GLEN AT WIDEFIELD FILING NO. 9
SPRING GLEN DRIVE (Sta. 30+00 to Sta. 43+00)
PLAN AND PROFILE
EL PASO COUNTY, COLORADO

Project No.:	17038
Date:	December 15, 2017
Design:	AWMc
Drawn:	JAK
Check:	AWMc
Revisions:	
SHEET	2

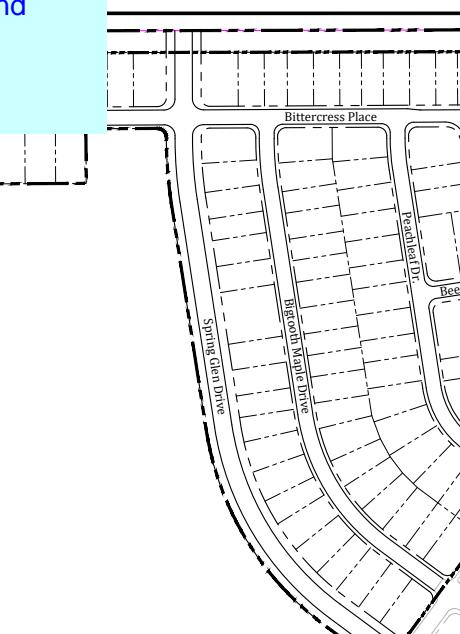
Revise all references
from "Development
Services Department"
to "Planning and
Community
Development
Department"

Add as a 3rd paragraph:

In accordance with ECM Section 1.12, these construction documents will be valid for construction for a period of 2 years from the date signed by the El Paso County Engineer. If construction has not started within those 2 years, the plans will need to be resubmitted for approval, including payment of review fees at the Planning and Community Development Directors discretion.

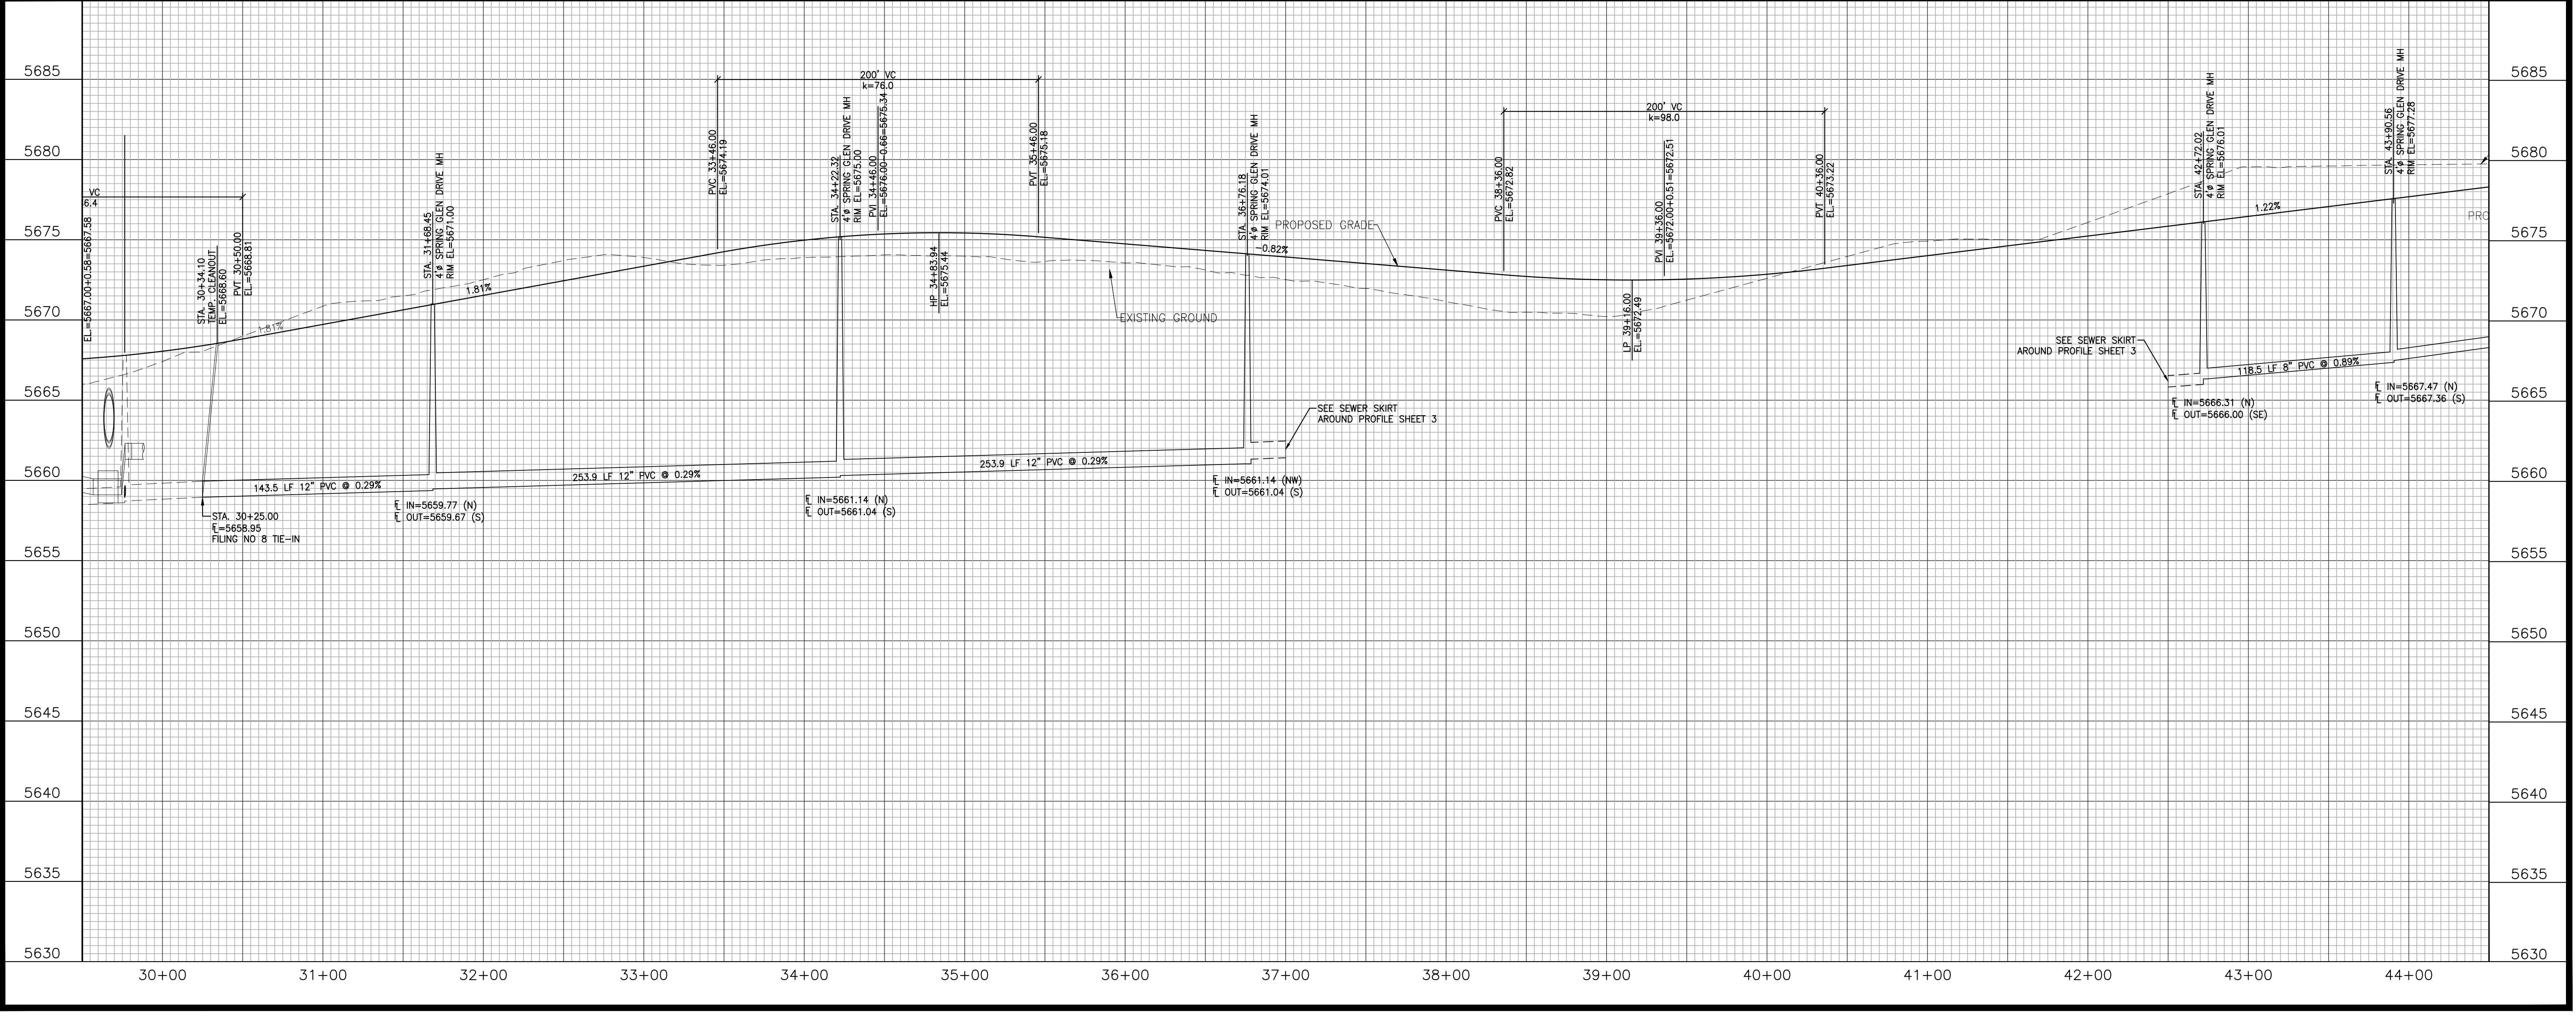
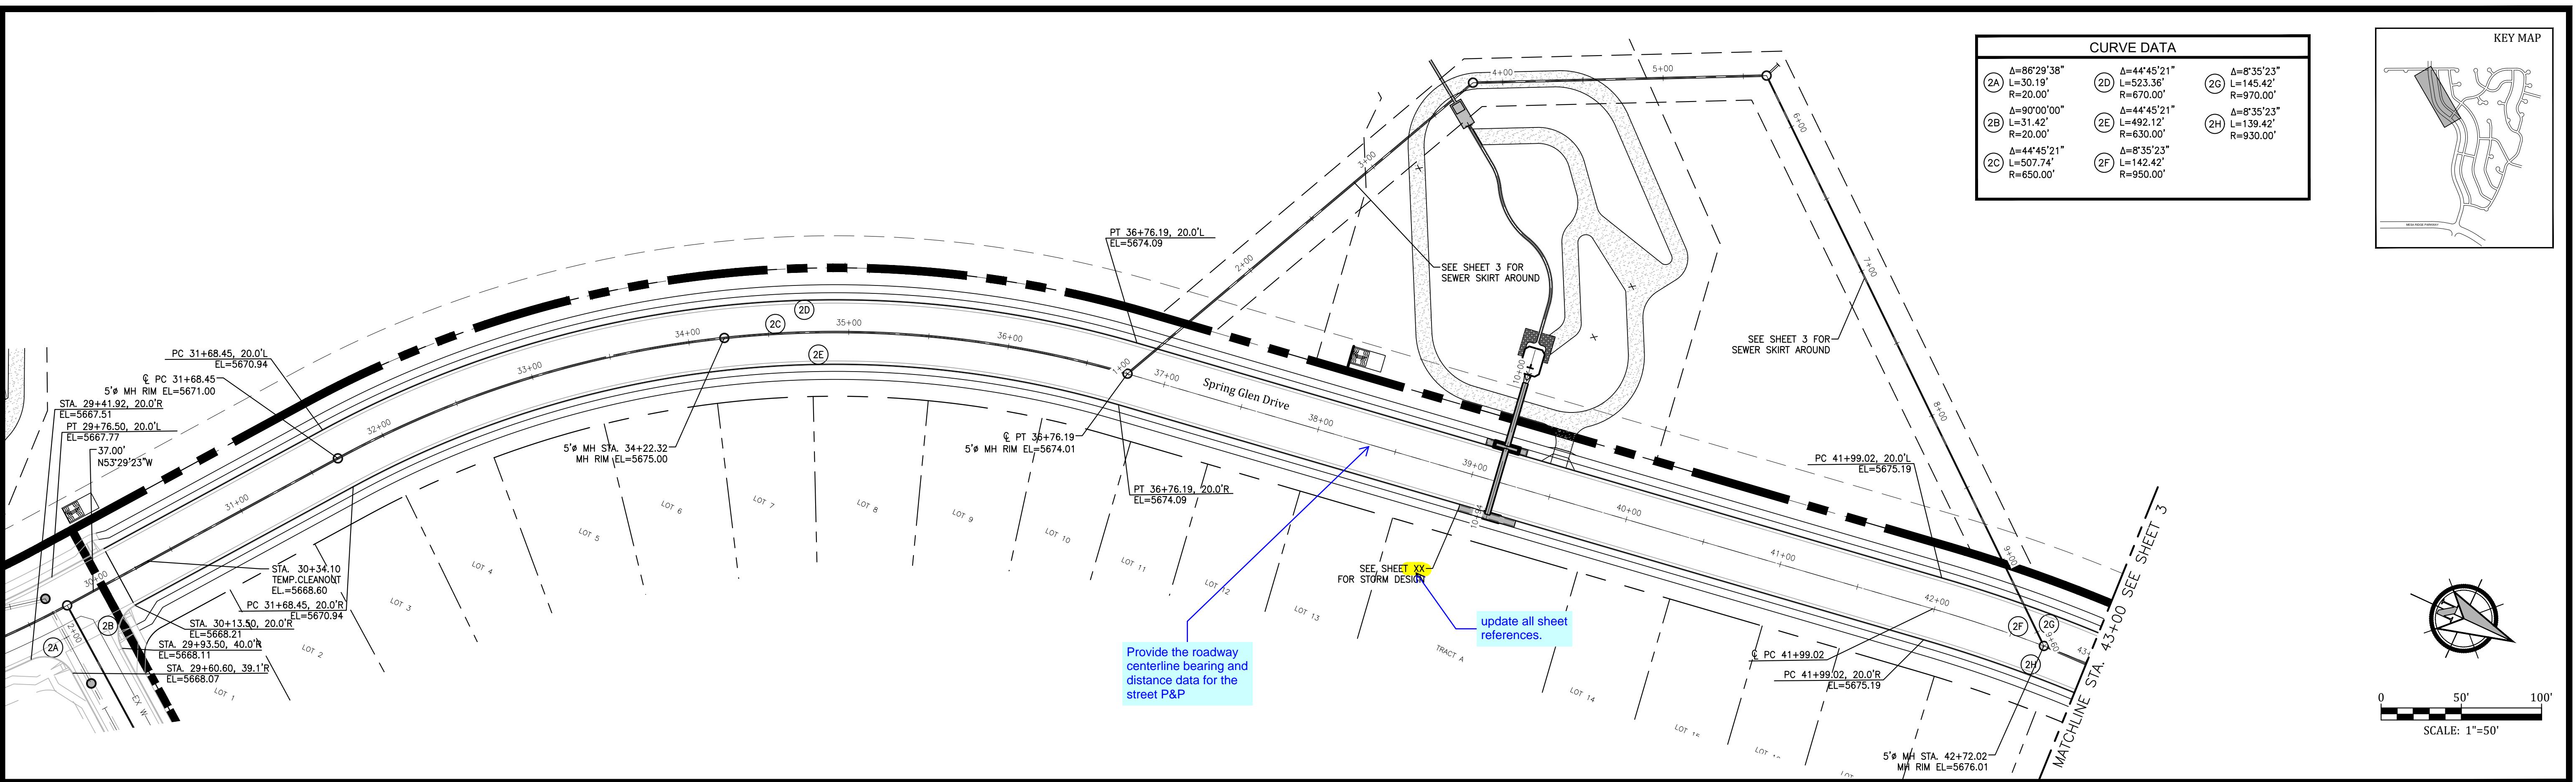
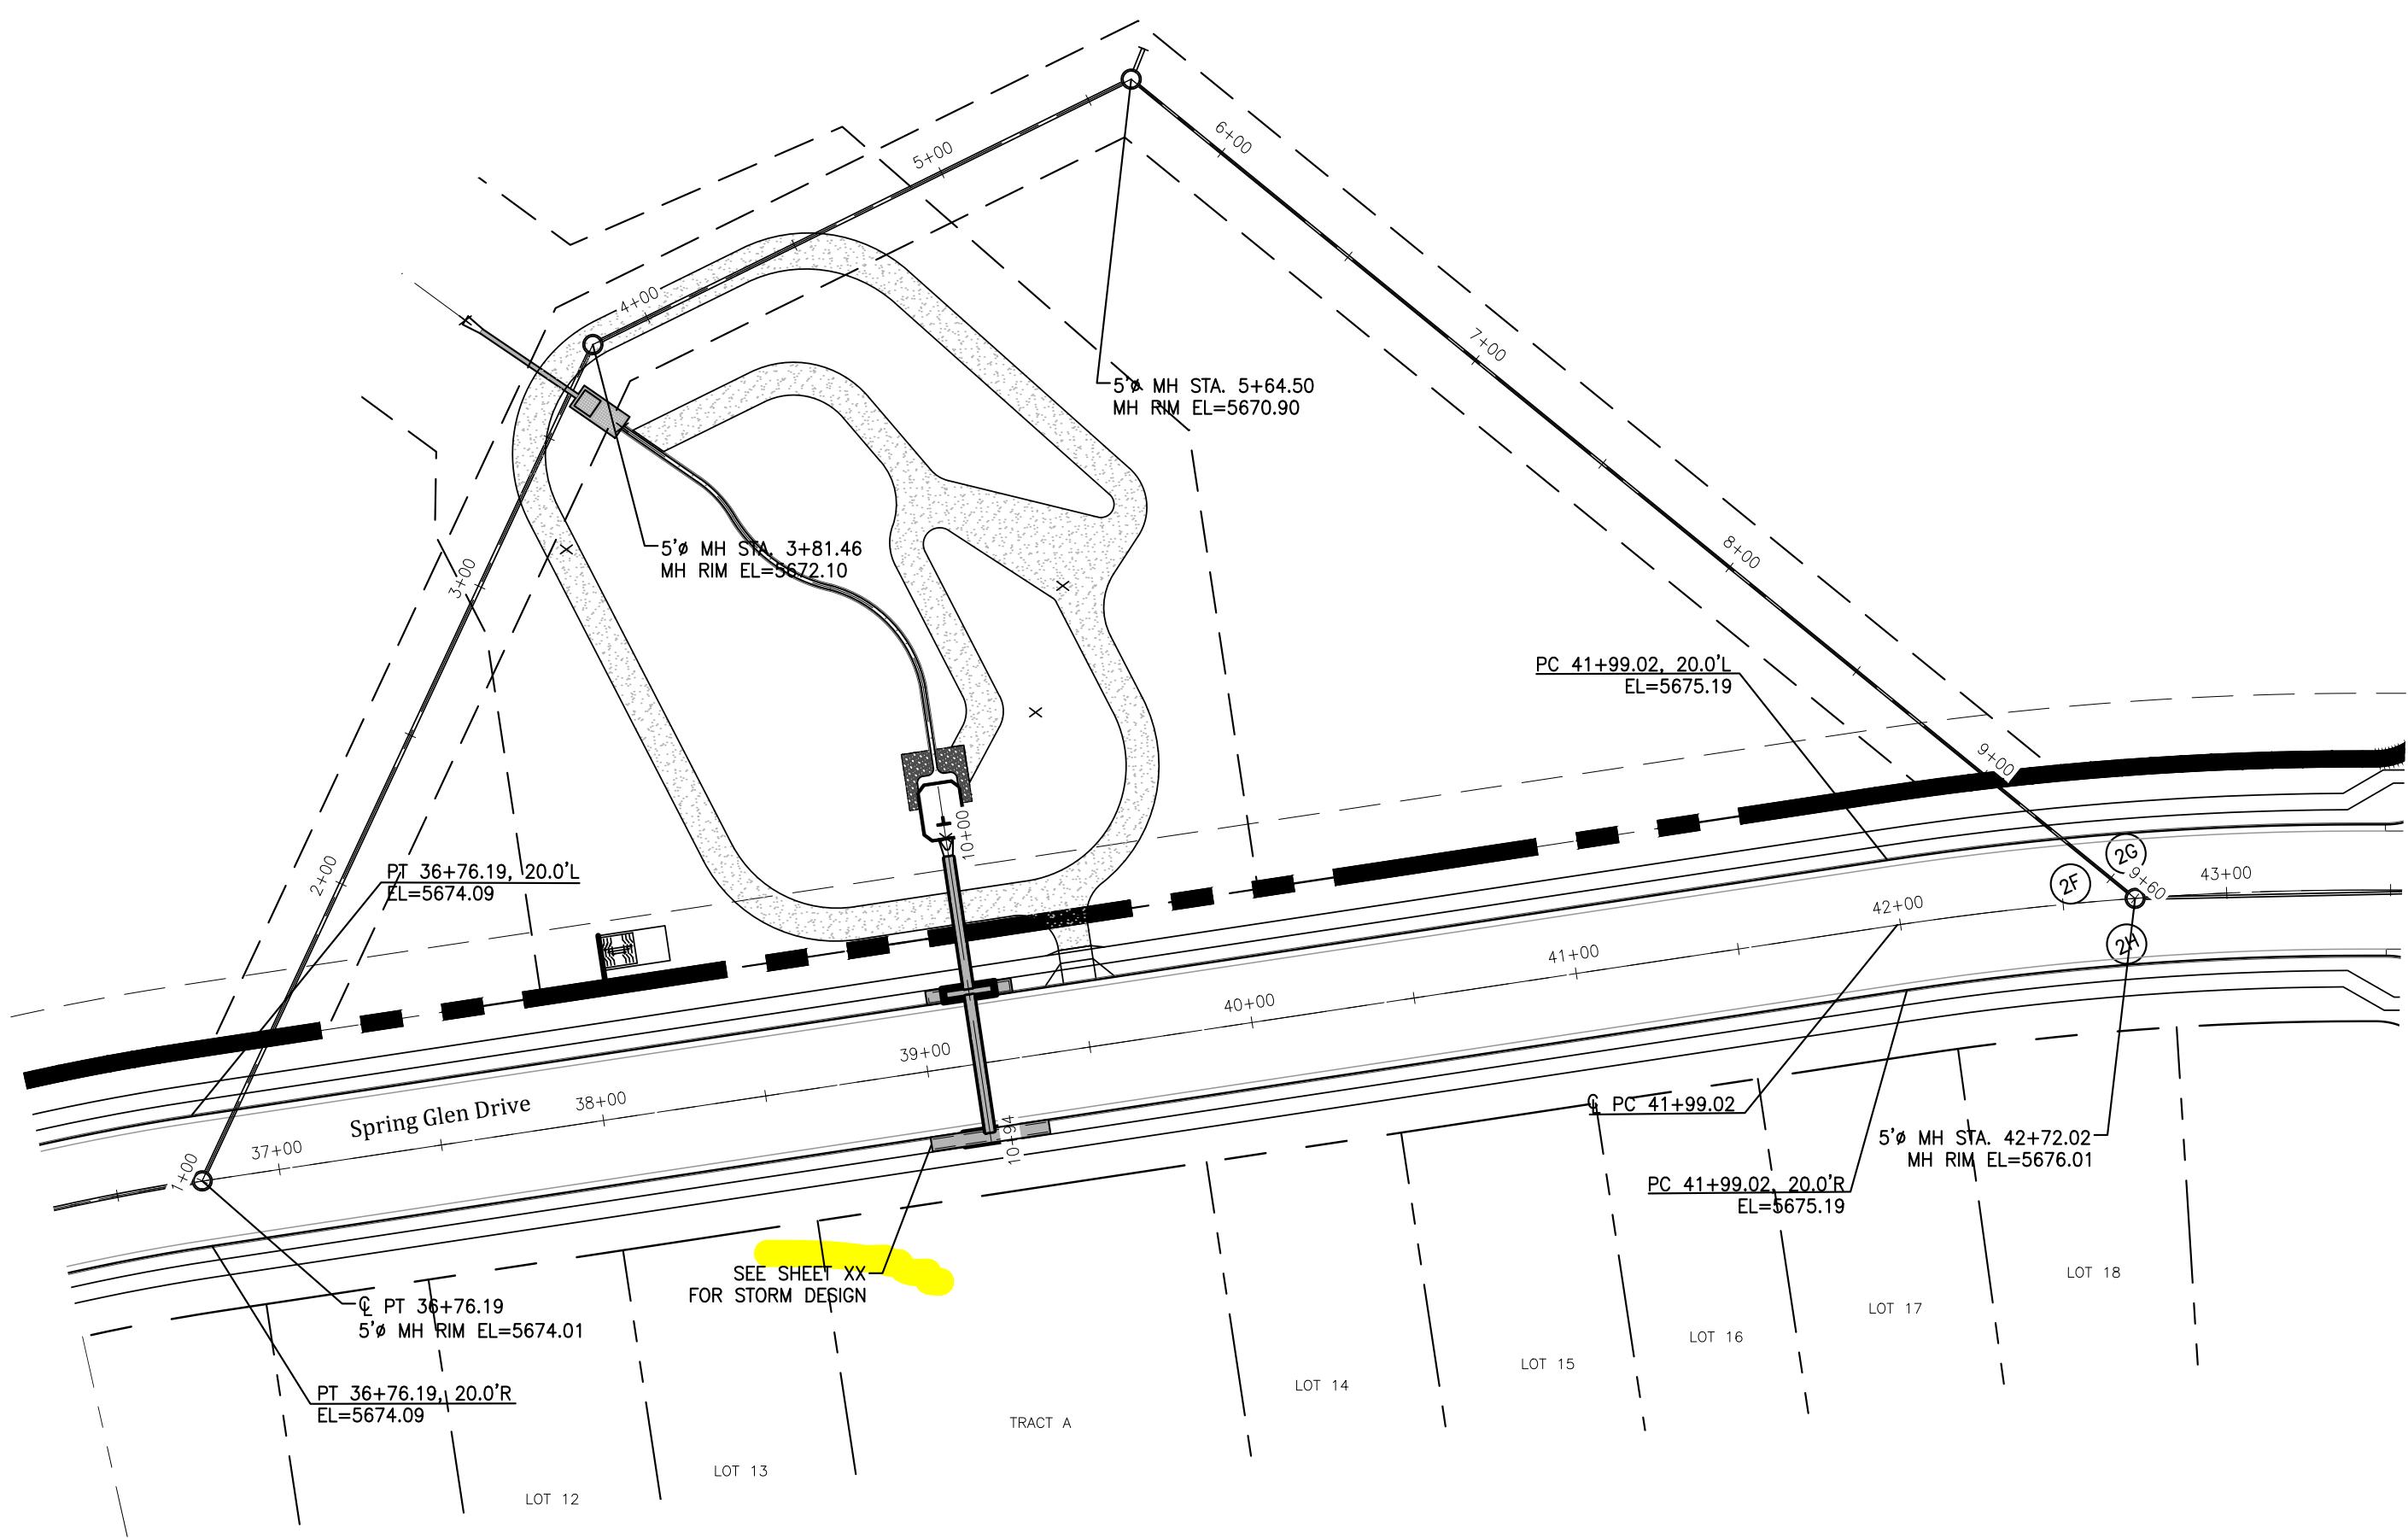
Adjust ROW at intersections so the sidewalks are completely the ROW.

Identify the width/thickness of the crosspan at all locations. The cross pan detail notes different width and thickness depending on the road classification.

update street names.
